## **ADDENDUM 7**

### **Miami Lakes Library Branch**

EXTERIOR IMPROVEMENTS AND COMPREHENSIVE INTERIOR RENOVATIONS

**C23-MDPLS-02-ESP**

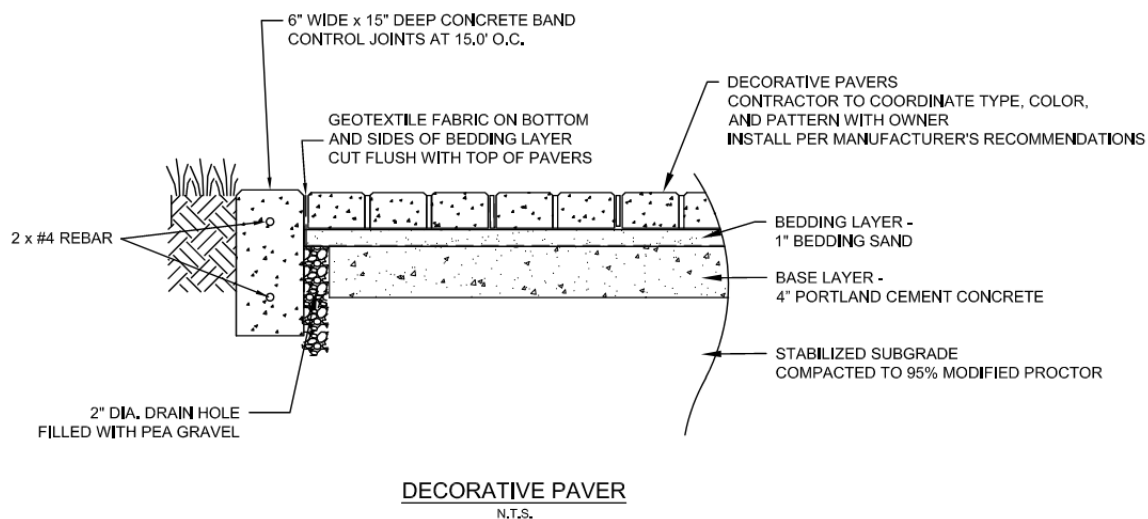
Q153. Plan Sheet C1.01 shows only seven (7) trees being removed from the site, but plan LA1.01 shows the removal of 22 trees. Please clarify discrepancy.

Q155. Plan Sheet C5.01 only shows installation section and detail for the permeable pavers area at the parking extensions but is missing the standard details for the pedestrian decorative pavers on sand at the main entry plaza. Base layer? Sub-base layer? Geotextile fabric? Please provide details for decorative pavers installations.

**A153. Refer to the direction on the landscape plans related to existing, removals, and new plant materials.**

**A155. See attached detail for the installation method. See Partial Site Plan 1/A1.5 for the paver types per location. See the Finish Schedule on Sheet A1.3 for the manufacturer, color, and size.**

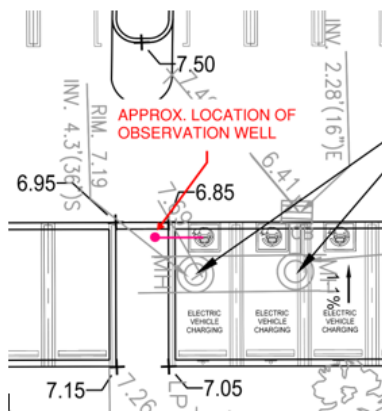
**Q156.** Plan Sheet C5.01 includes detail 7/C5.01 showing a drainage pipe section with perforated PVC pipe but is it unclear to us where this section is located and how many locations of such pipe are required. Locations of this detail are not shown in Site plan or in Paving and Grading plan. Please clarify locations and show them in Paving plan.

**A156.** *One observation well is to be located in the area of the lowest subgrade elevation in the row of new permeable paver parking spaces . The perforated PVC pipe shall extend a minimum of 4.0 feet into the aggregate base layer per detail. See attached sketch.*
